CITY OF ALBUQUERQUE

Re: NMUI Well No 9 Grading and Drainage Plan
Engineer's Stamp dated 12-27-04, (C9/D5)

NEW MEXICO UTILITIES, INC. WELL NO. 9

GRADING AND DRAINAGE PLAN

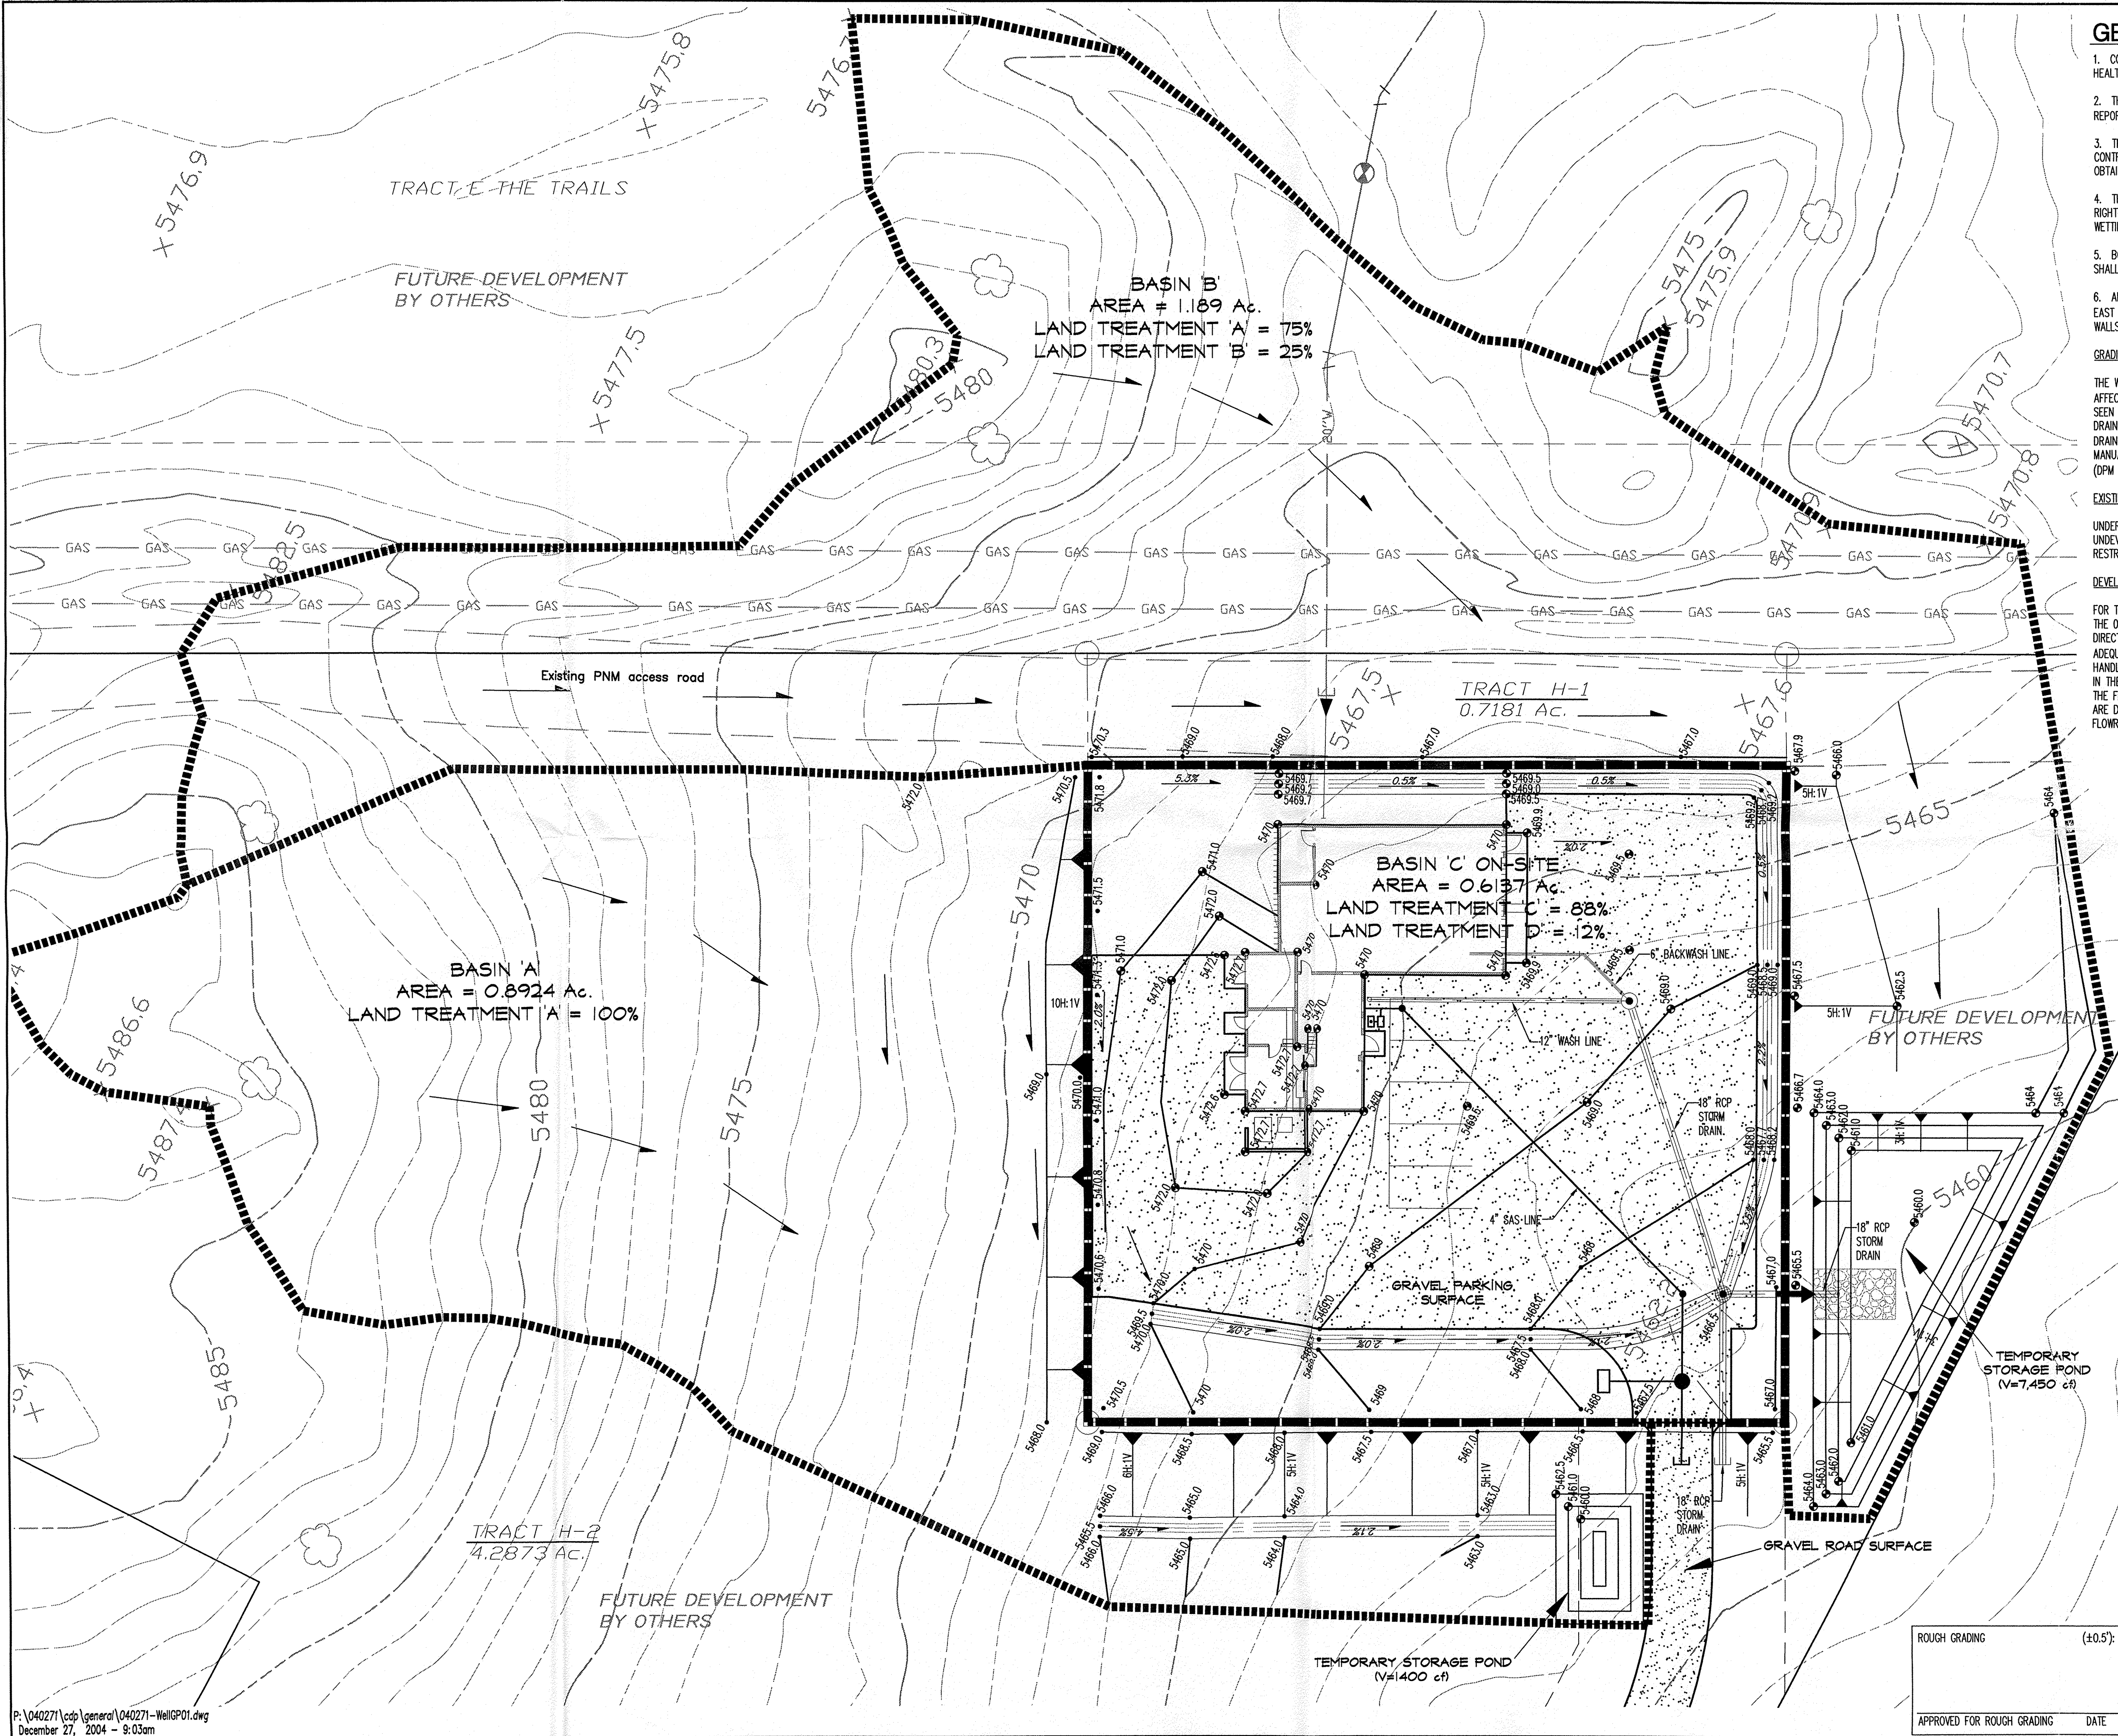
Based upon the information provided in your submittal dated 12-27-04, the above referenced plan is approved for Preliminary Plat, Site Plan and Building Permit. Please attach a copy of this approved plan to the construction sets prior to sign-off by Hydrology.

Also, prior to Certificate of Occupancy release, Engineer Certification of the grading plan per the DPM checklist will be required.
